5 July 2024

RE: Noise Assessment and Mitigation Design Recommendations
Lower Skyway Pump Station, Update #1
EDI Job # C-4459

Figure 3.1.1: Main Access Entry Door

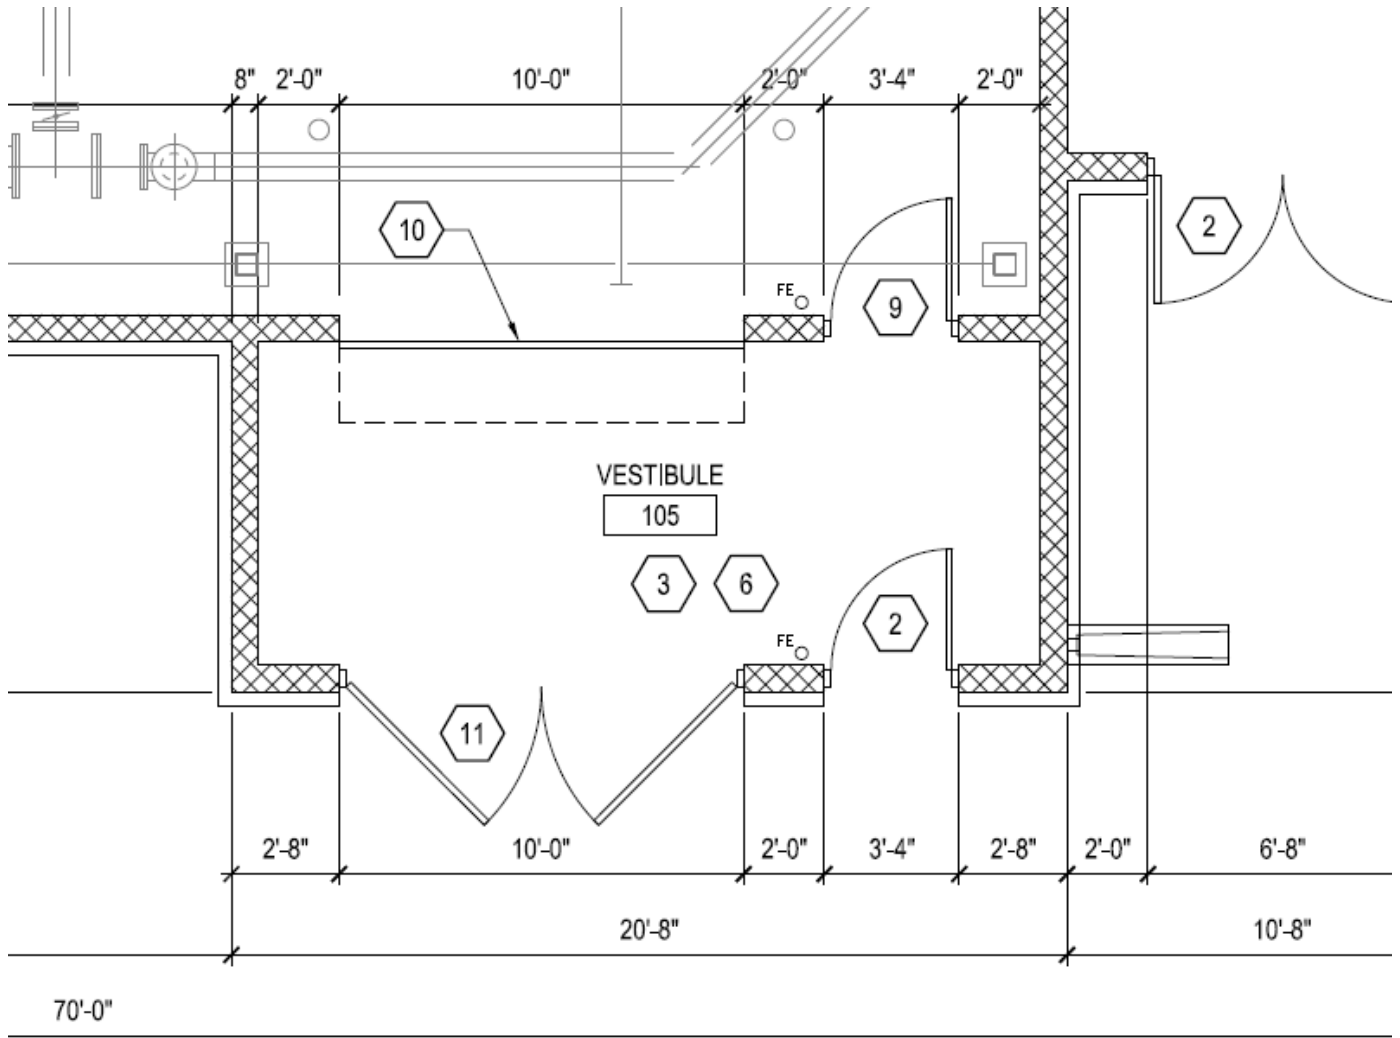
3.1.1 Entry (Room 104)

Keep proposed vestibule at main entry access door as shown in Figure 3.1.1. Vestibule construction shall be

- a. Walls as shown on 30% design drawings.
- b. Roof as shown on 30% design drawings.
- c. Entry Doors shall be steel door with jamb smoke seals and door bottom sweep or automatic door bottom.
- d. False window construction as shown in Figure 3.1.3.

Figure 3.1.2: Maintenance Access Vestibule

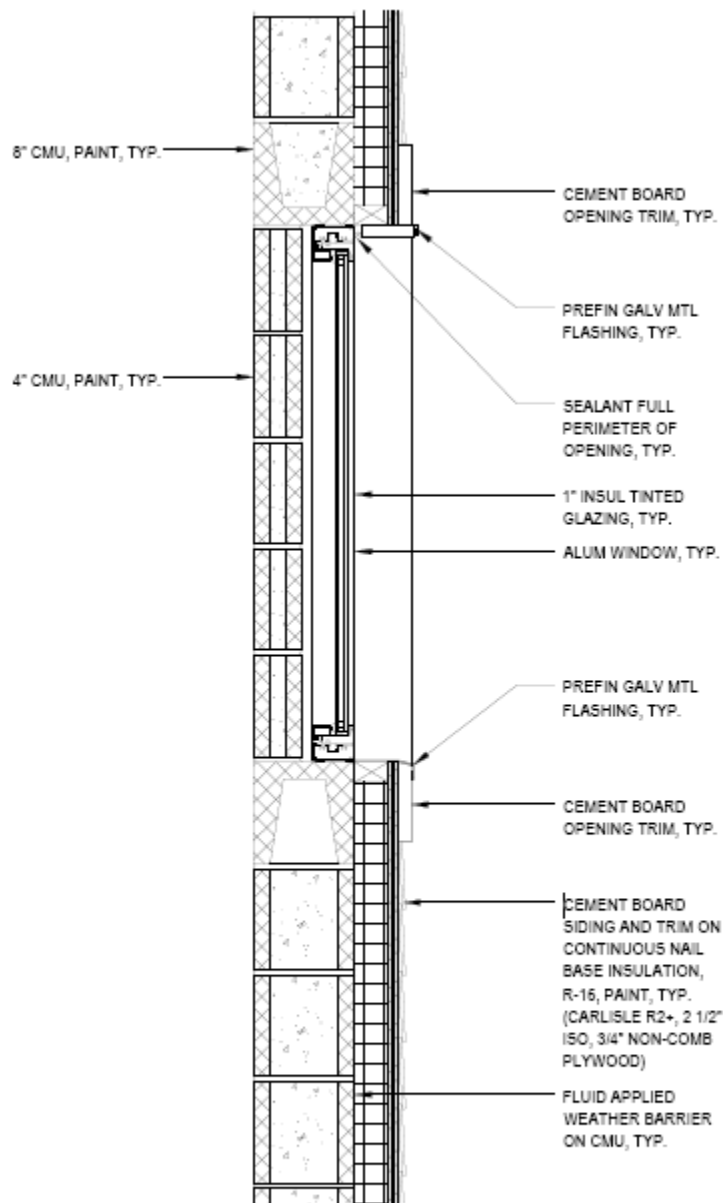
3.1.2 Vestibule (Room 105)

Keep proposed vestibule at maintenance access door as shown in Figure 3.1.2. Vestibule construction shall be

- a. Walls as shown on 30% design drawings.
- b. Roof as shown on 30% design drawings.
- c. Entry Doors shall be steel door with jamb smoke seals and door bottom sweep or automatic door bottom.
- d. False window construction as shown in Figure 3.1.3.
- e. Proposed maintenance doors are acceptable, however, carriage doors must have
 1. jamb seals around sides and top of door,
 2. Astragal seals,
 3. Door bottom seal / sweep,
 4. Door thickness must be minimum of 3 inches solid wood, and
 5. Glazing in door must have a minimum STC rating of 28.

- f. Install a minimum of 80 sq. ft. of absorptive panel onto the ceiling and uppers walls of the vestibule. The acoustic panel shall have a minimum Noise Reduction Coefficient (NRC) of 0.75 as installed. This will absorb some of the noise transmitting through the inner roll-up door, before transmitting through the outer door.
